MEMORANDUM

CITY/BOROUGH OF JUNEAU
155 South Seward Street, Juneau, Alaska 99801

FILE NO.: VAR20110027

PROPOSAL: A Variance request to the 50' streamside setback of Duck Creek for the installation of a water line and meter.

C-1

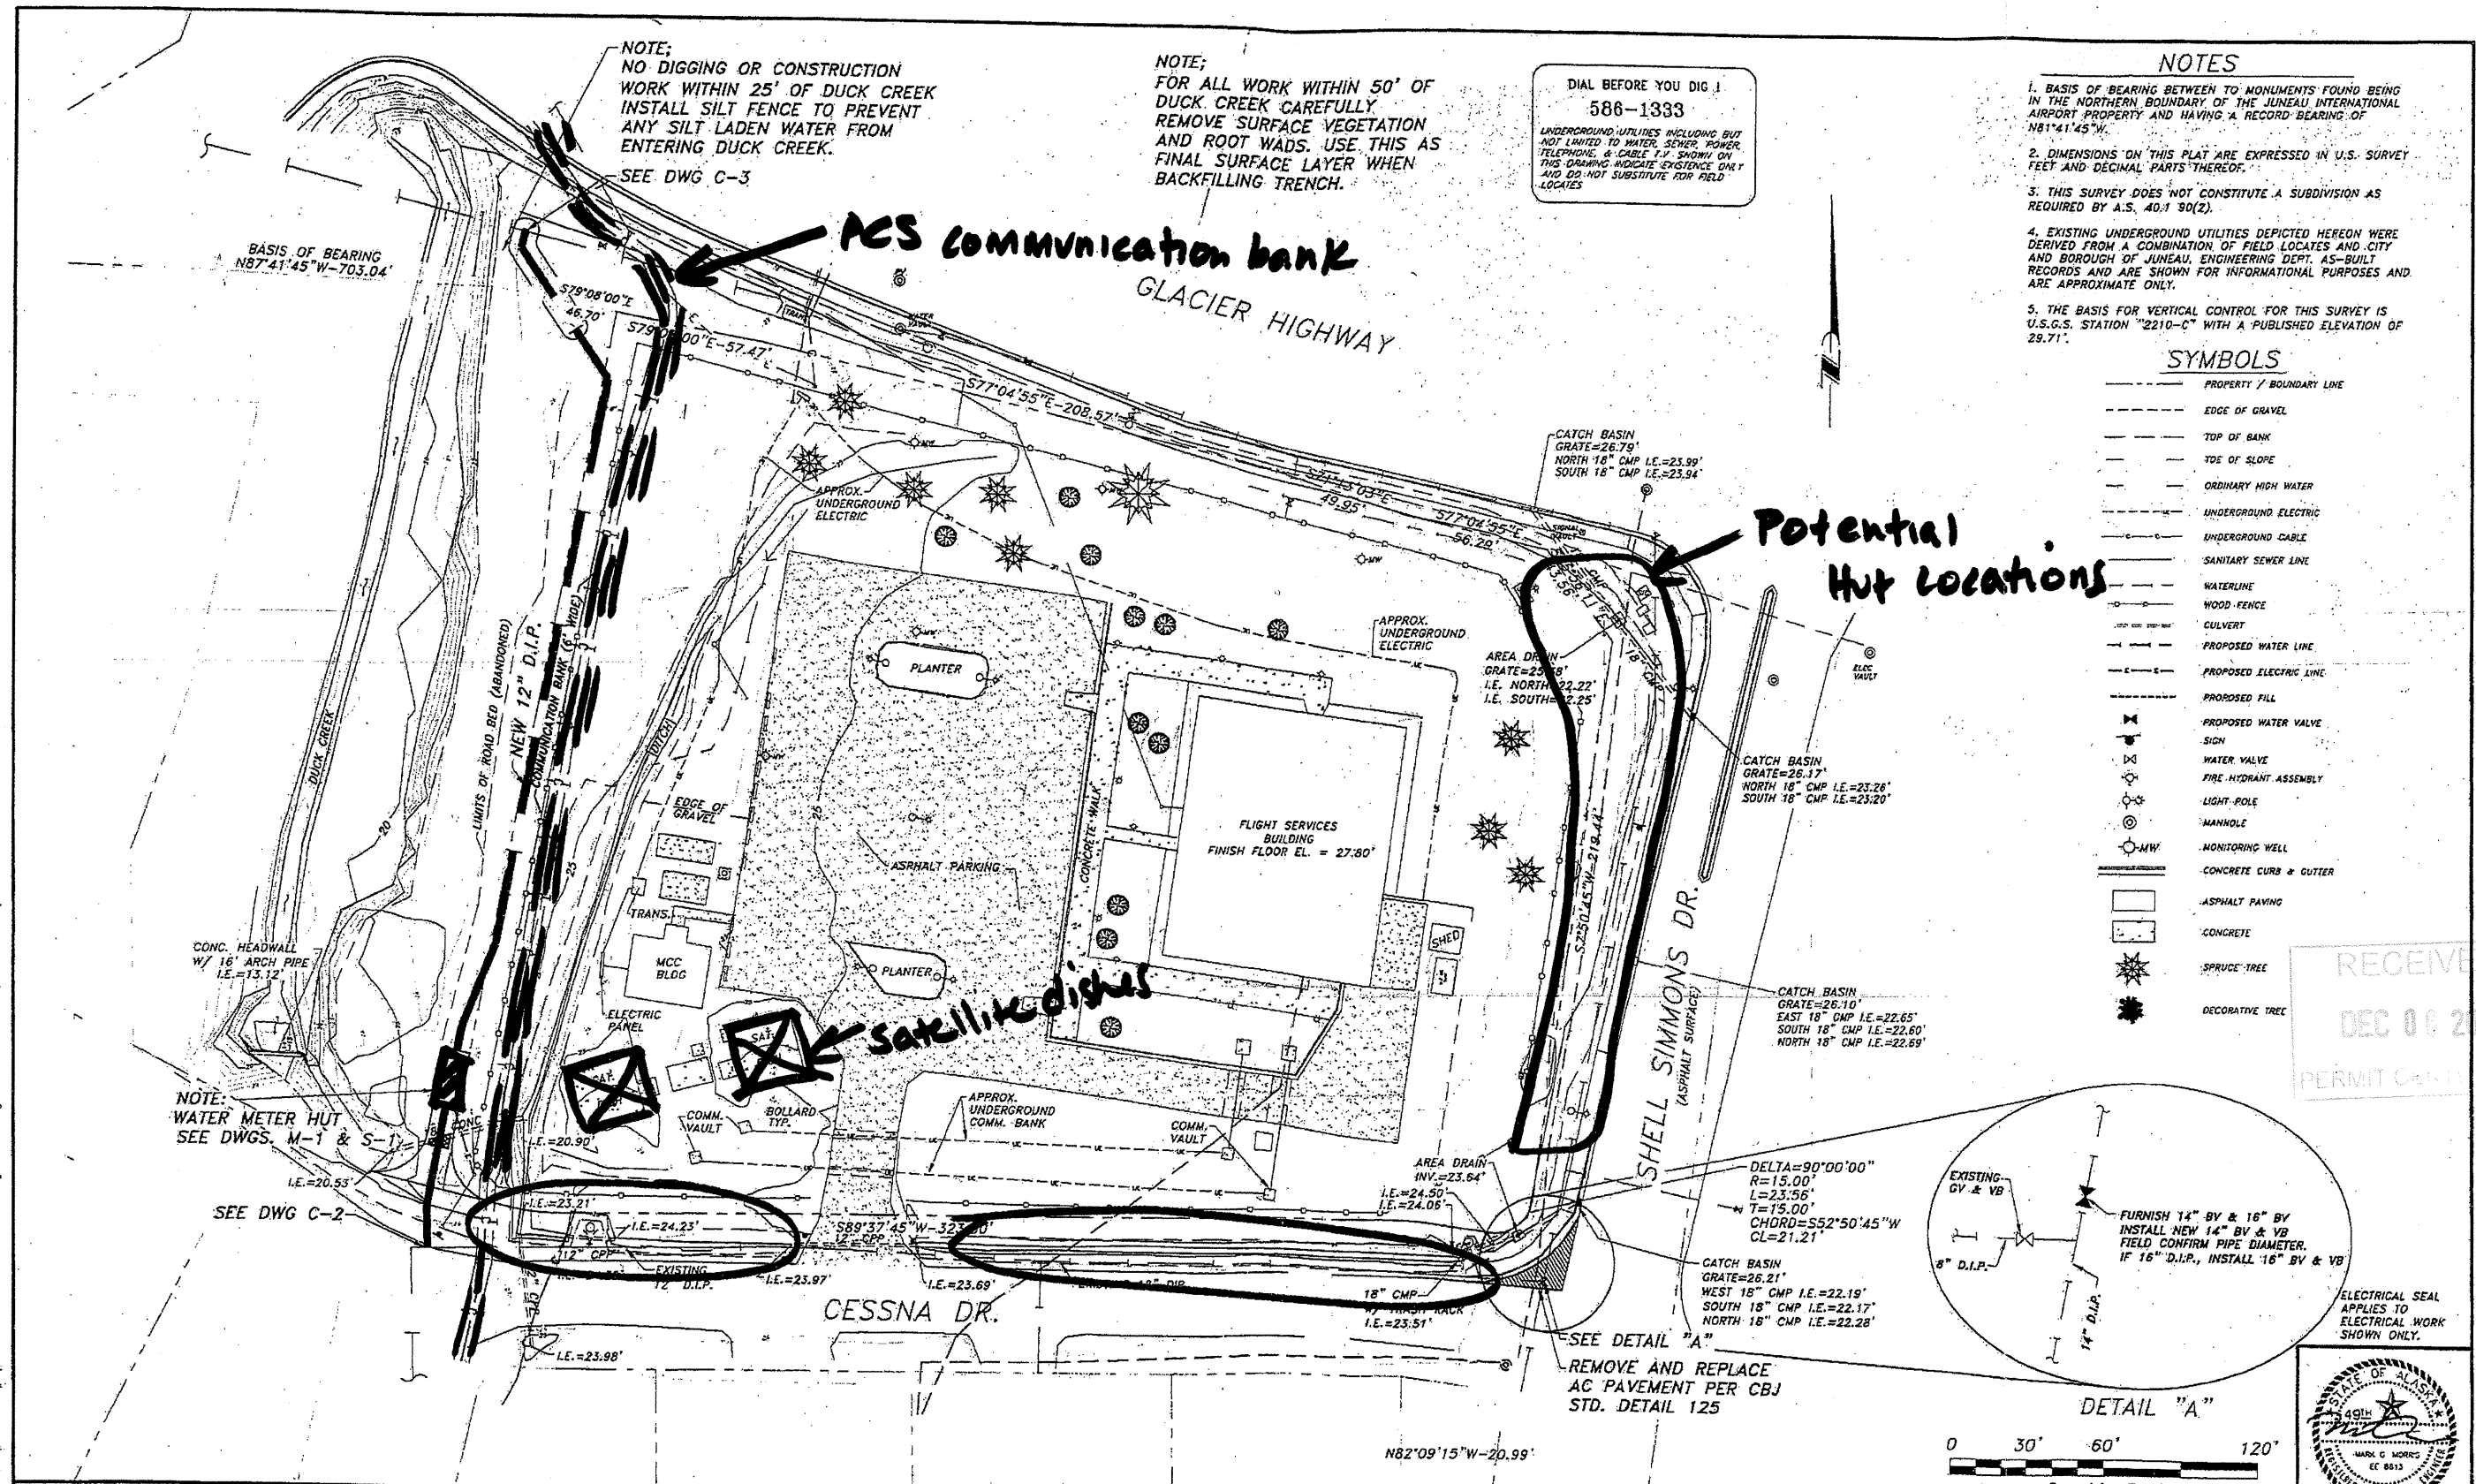
This area is within
the 50' setback

Based on the design drawings you provided, it does not appear that there will be any long-term loss of riparian habitat in the setback as the water line will obviously be installed underground. My only recommendation would be to salvage as much of the existing vegetative mat and the small trees in the project corridor for use in revegetating the area following installation of the line. For example, some of the spruce trees look small enough for an excavator to remove and replant following construction. Once the alders and other large trees are cut, an excavator could scrape off 6 to 10 inches of the topsoil and associated plants and use these mats for revegetating the site as well. Although I've never really seen plants salvaged from a site used for post-construction revegetation, I don't see why it would not work. The benefits will be a much quicker recovery of the riparian plant community and a much lower chance of invasive plant species becoming established. Michele Elfers is certainly experienced with good revegetation practices so I'm not too worried about recovery of the area.

The Board concluded that options were available which did not impact that 50' setback and expressed disappointment that the city was not held to a higher standard for avoiding impacts. The Board has consistently opposed development within the 50' setback on private properties. On the proposed site, the Board thought that it might still be possible to avoid impacts in the 50' setback if the communications bank was exposed before excavation work began.

The Board is aware that there are alternatives that would not affect the 50' setback, but those alternatives have unfortunately not been presented as options. Regarding the current proposal, the applicant should initially identify and excavate the existing conduit locations, to determine the most direct route for the water line to minimize or eliminate impacts within the 50' setback. The Board supports knotweed removal within the impacted area of the project and replacement of vegetation within the 50' setback with vegetated mats. The Board strongly opposes development in the 50' setback of Duck Creek and encourages the applicant to make every effort to avoid impacting these areas if possible.

3. The applicant shall make all efforts to connect the new water line to the water main as close to the ACS bank as possible, minimizing encroachment into the 50' setback.

NOTE;
FOR ALL WORK WITHIN 50' OF
DUCK CREEK CAREFULLY
REMOVE SURFACE VEGETATION
AND ROOT WADS. USE THIS AS
FINAL SURFACE LAYER WHEN
BACKFILLING TRENCH.

DRAWING
C-3
SHEET No.
6 of 10

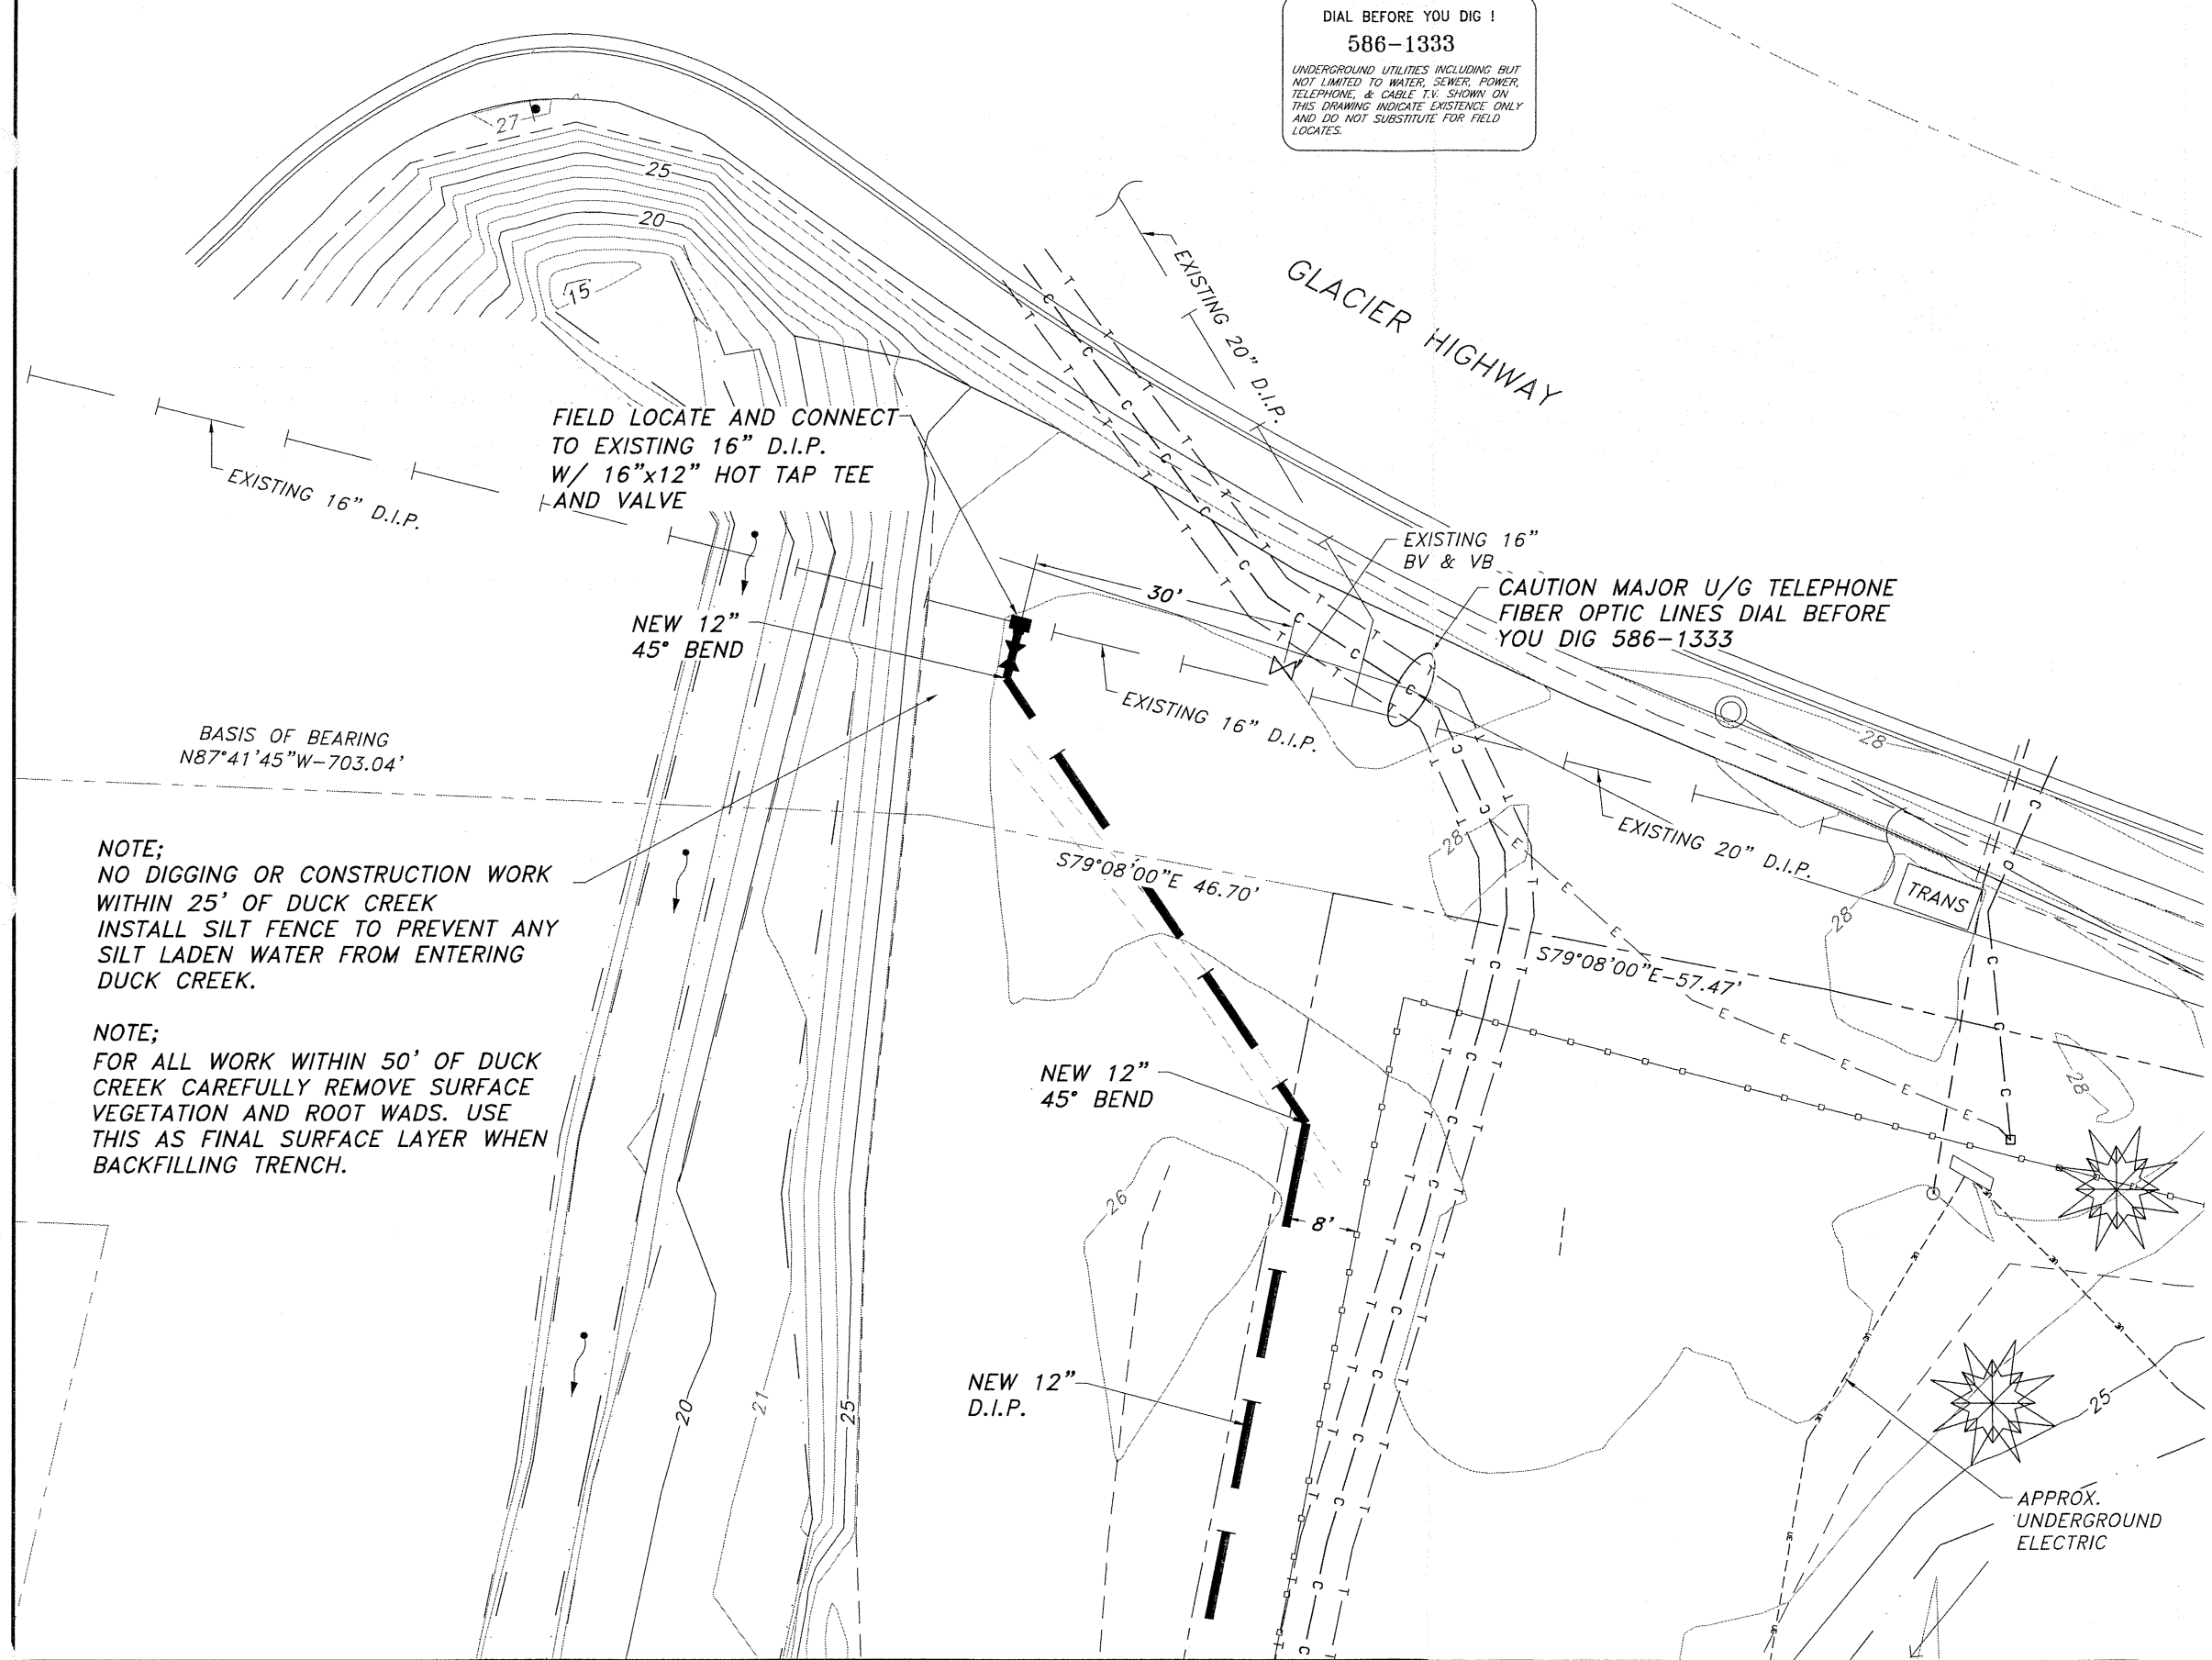
The location initially proposed for the airport water meter hut was on Cessna Drive close to the intersection with Shell Simmons Drive. (See attached Sheet C-3, dated July 2011). The water department preferred this location because they could connect to the water line running along Cessna Drive and intersect the water going to the airport. However, the airport manager informed us that this location was not acceptable because the airport had future plans to develop this lot commercially. A utility hut could affect these plans. The water department and the airport manager then looked at various locations between Glacier Highway and Shell Simmons intersection, down Shell Simmons Drive, and down Cessna to intersect this water line. For reasons relating to the future plans for this lot where the FAA building currently sits, the current operations of the FAA building such as satellite dish clear zones, and ADOT Right of Way the water meter hut could not be located anywhere in this area. Finally, in November, the water department and the airport were able to agree to the current location as it will not be an obstruction to future commercial uses of the property. An additional constraint is a major communication bank for ACS is running just to the east of the water line that connects to this meter. To avoid crossing this bank and risking damage to the main communication lines for the Mendenhall Valley, the water line stays to the east and runs along the fence to the FAA lot. See the attached sheet C-1 dated November 2011.
